MIL-G-50678C (AR)
AMENDMENT 2
28 December 1992
SUPERSEDING
AMENDMENT 1
24 June 1991

MILITARY SPECIFICATION

GATE, MULTIPLE, CIRCUITS: 9342754

FIGURE 5. Multiple gate circuit test setup.

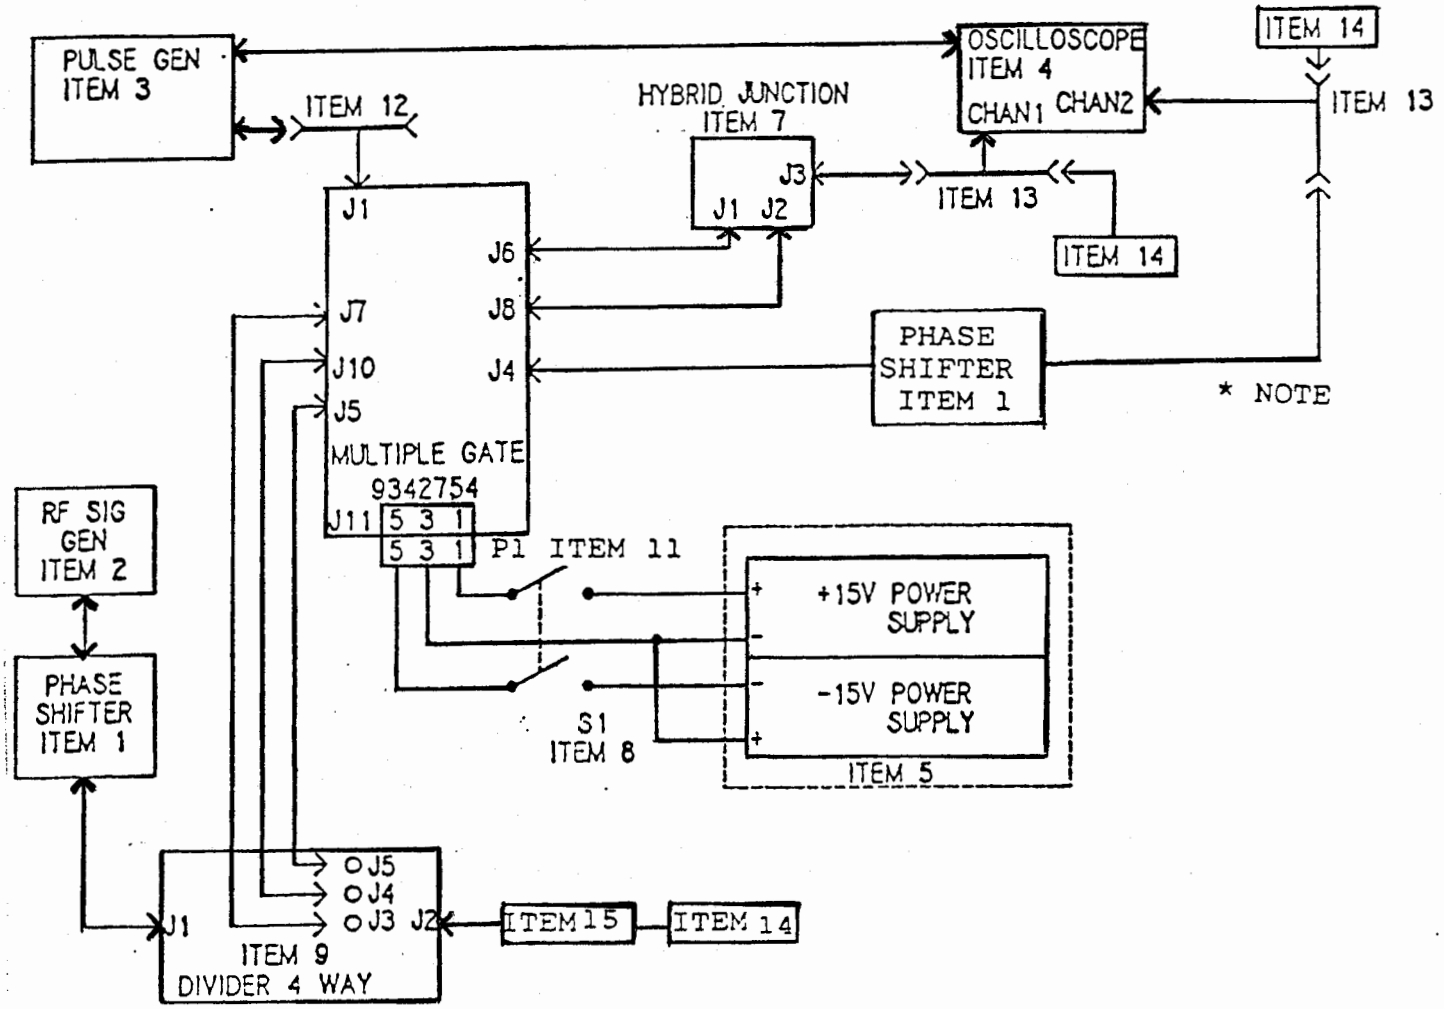
Add new paragraph 3.5.2.3.4 as follows:

Add new Figure 5 as included page 6A.

Add new paragraph 4.7.3.4.4 as follows:

"3.5.2.3.4 Gate noise. With the multiple gate connected with the test setup as shown in Figure 5, a 60 ± 1% MHz signal and a monitored 2.8 V p-p signal per gate applied to J5, J7 and J10 of the unit under test, the amplitude of the algebraic sum of the Early Gage and Sum Gate signals during the Early Gate period shall be less than 1.0 V p-p. The amplitude of the algebraic sum of the Late Gate and inverted Sum Gage signals during the Late Gate period shall be less than 1.0 V p-p."

"4.7.3.4.4 Gate noise. Connect the unit under test to the test setup per Figure 5. Adjust channel 2 Phase Shifter so that the Early Gate on channel 1 is 180° out of phase with the Sum Gate on channel 2. Adjust variable gain on channel 2 for equal amplitude waveforms on channels 1 and 2. Place oscilloscope in channel 1 and 2 algebraic add function and readjust channel 2 phase shifter for Early Gate null. Resultant waveforms in the Early Gate shall be less than 1.0 V p-p. Place oscilloscope channel 2 in invert mode. Readjust amplitude and phase for Late Gate null. Resultant waveforms in the Late Gate shall be less than 1.0 V p-p."
